ADNOC GAS HABSHAN & BAB CONTROL SYSTEMS UPGRADE (PACKAGE 1) PROJECT NO. 0405323						  				
			COMMENTS RESOLUTION SHEET										
Document Title:			PIPING & INSTRUMENTATION DIAGRAM 13-C-102 TURBINE DRIVE & AUXILIARIES EARLY THAMMAMA 'B' (HABSHAN)				AGP Response Code			Prepared By:	VK		
Document No:			13-00-209		Revision No:	B		1. Revise and Re-submit		3. Approved	Checked By:	DV	
AG Ref. No:			ADNOCGP-WTRAN-002750		Date:	11-Feb-2024		2. Approved with comments	✓	4. For Information only	Approved By:	YVR	
SN	Reference		COMPANY Comments	CONSULTANT Response	COMPANY Resolution								
	Page No.	Clause No.											
1	1	Process Comment	Note 14 shall keep in the appropriate place.	Noted and updated									
2	1	Process Comment	Existing instrument tag number / New instrument tag number / Valve tag number shall specify.	Noted. However, we have not incorporated this comment as per discussion during design review meeting.

PIPING & INSTRUMENTATION DIAGRAM

13-C-102 TURBINE DRIVE & AUXILIARIES

13-00-209

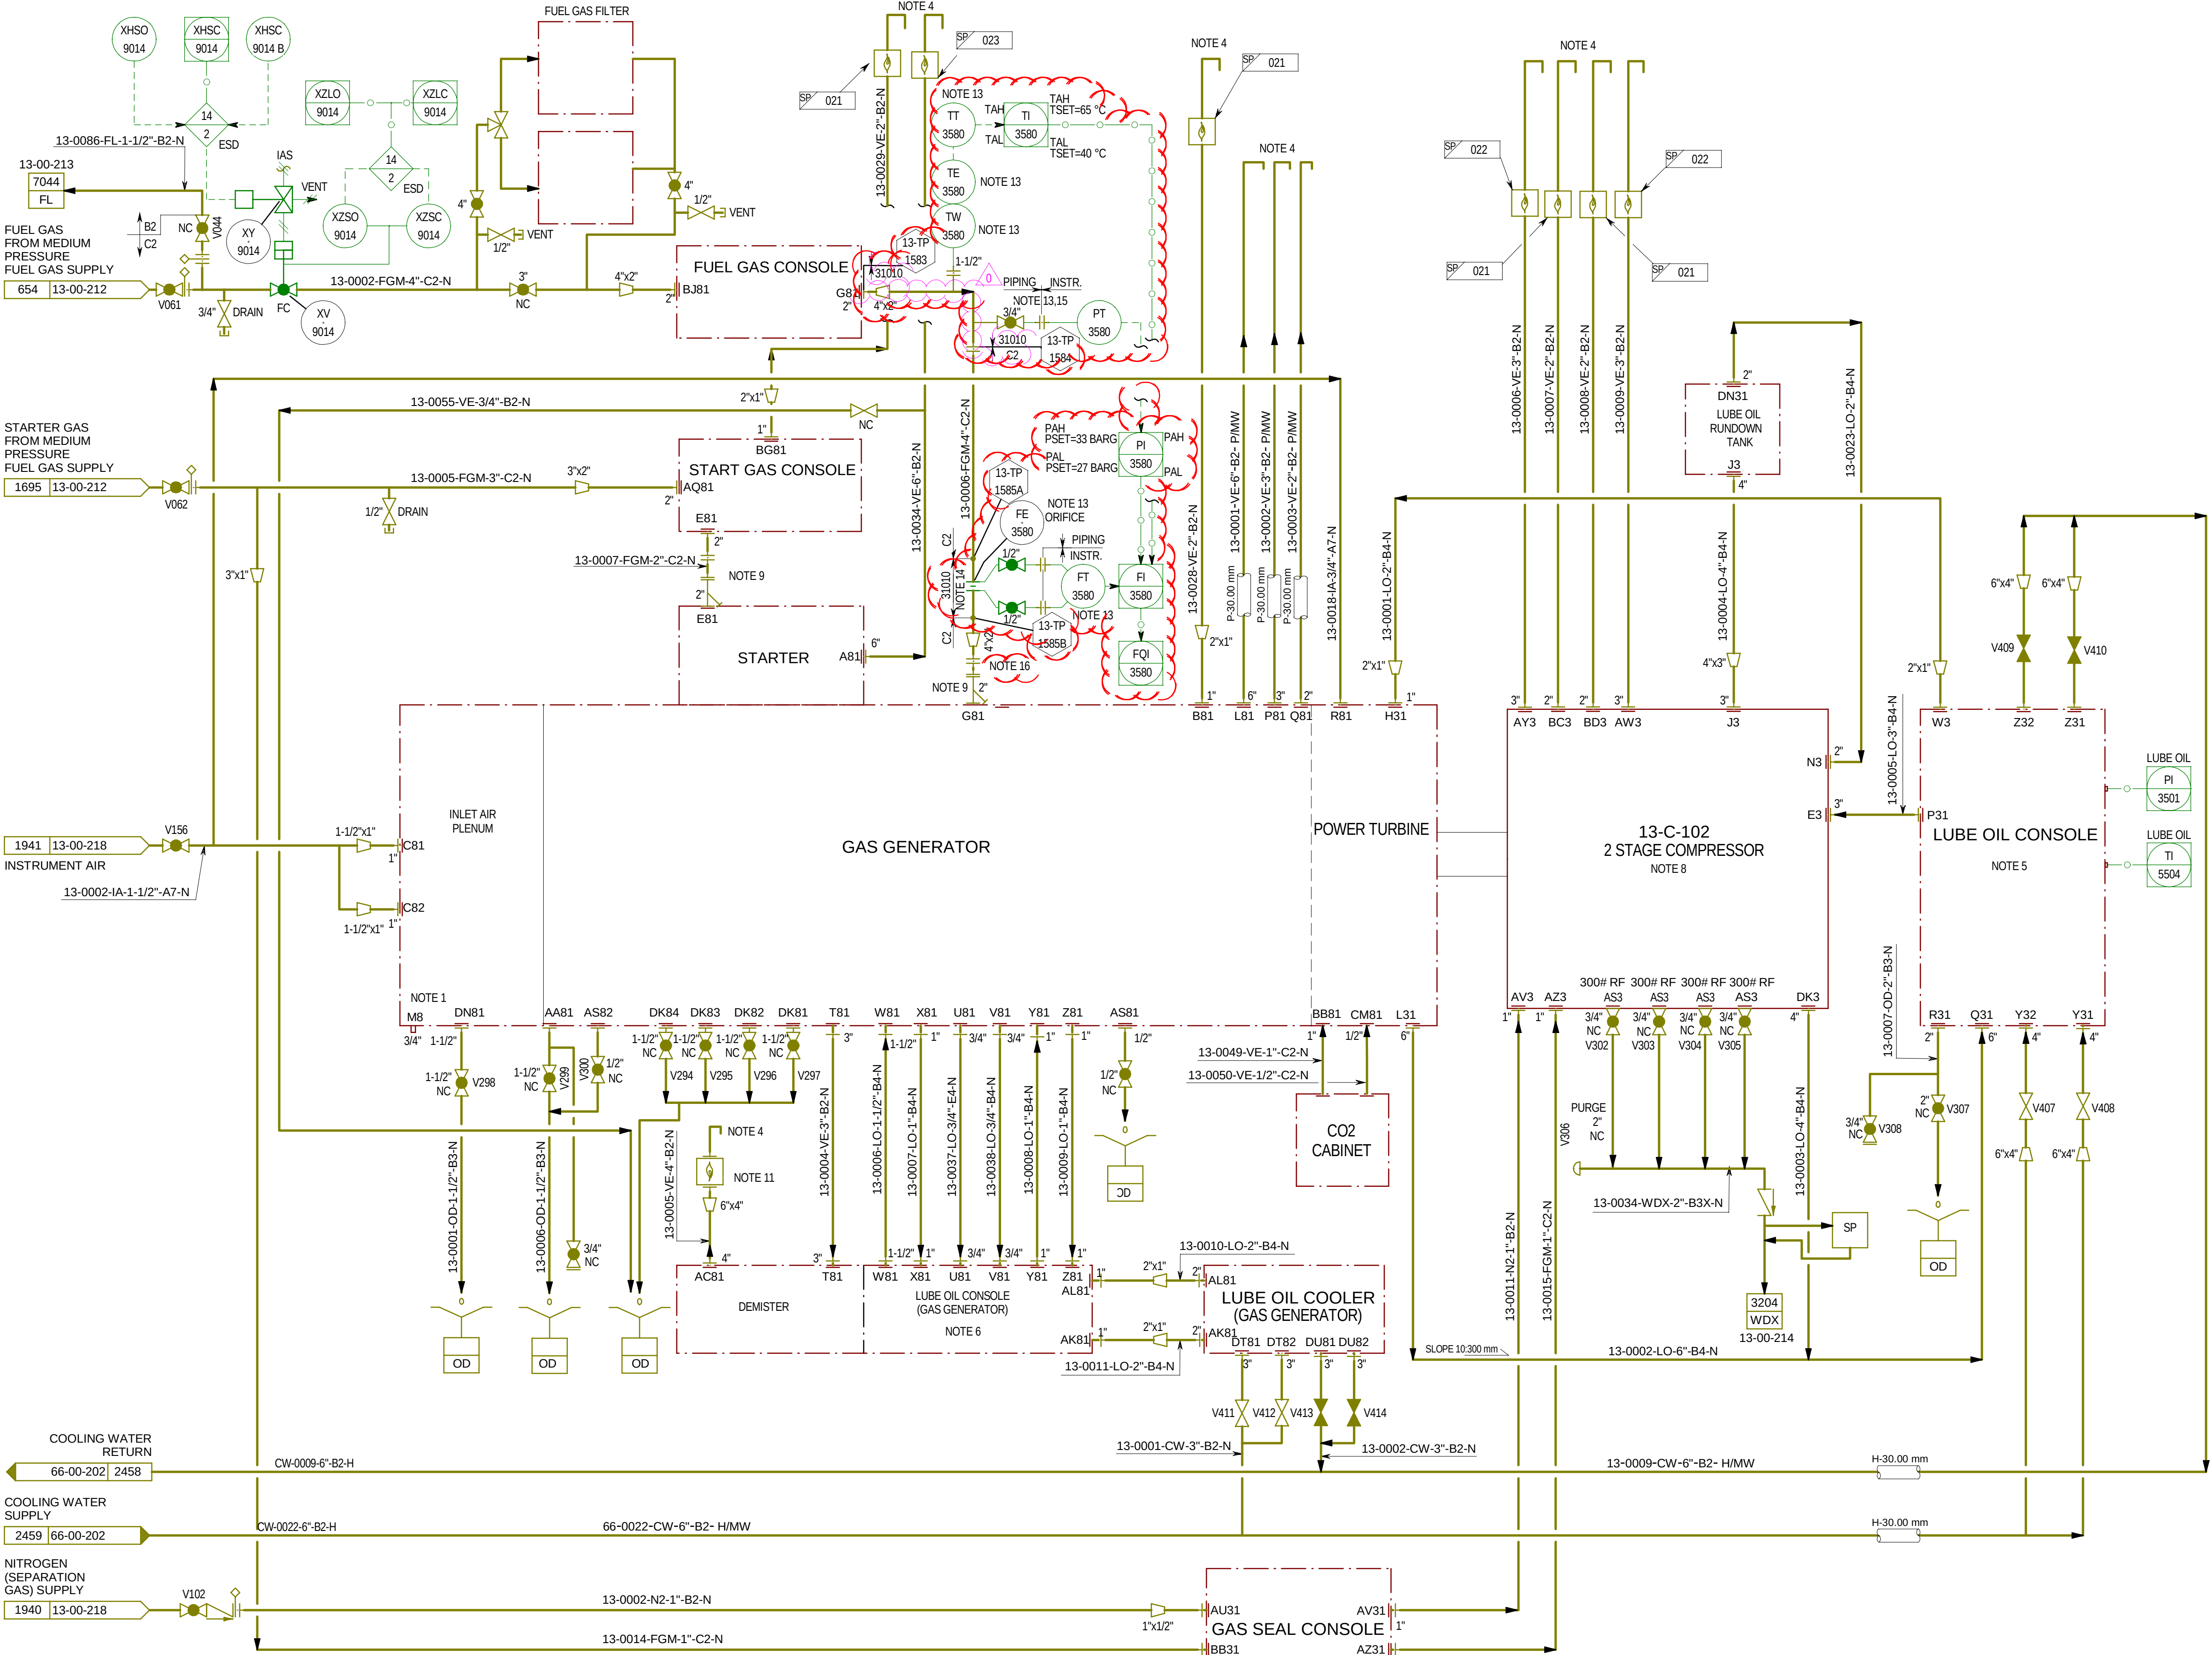
3	1	Process Comment	Please review the isolation valve / drain valve for the pressure instruments or confirm with the site photograph that no isolation valve is required.	Noted. We have already provided Isolation valve in Rev B P&ID.									
4	1	Process Comment	Why HOLD? This HOLD point is not justified.	Noted. Note 14 is updated and hold is deleted from P&ID.									
5	1	Process Comment	Why straight length requirement could not be specified for Orifice Flow Element? Why awaiting vendor info? BTME to clarify.	Noted and straight length is updated.									
6	1	Process Comment	1. Holds shall be removed before submitting the next revision of the documents. 2. Alarm & Trip list document number shall be provided under the reference list. 3. Please provide the Legend P&ID number under the reference list. 4. DCS symbol / Local / functional symbol shall be shown in the legend. 5. The Isolation philosophy/ Cause & Effect document number shall be provided under the reference list. 6. Previous comments not incorporated.	1. Noted and holds are removed from P&ID. 2. Noted, However alarm and trip list document number is provided in Rev B P&ID. 3. Noted and legend reference is updated under reference list. 4. Noted. Refer legend reference added in reference section for DCS symbol legend. 5. As discussed for other P&IDs Isolation philosophy is not required in reference list. Cause & Effect document number is not required as there is no signal in our scope going to ESD. 6. All previous comments incorporated in Rev B

7	1	-	-	Following changes are made in P&ID w.r.t. Rev.B submission as per piping/instrumentation inputs. 1. Tie-in Point 13-TP-1583 & 1584 location and pipe class is updated as per piping input. 2. Note 17 added.
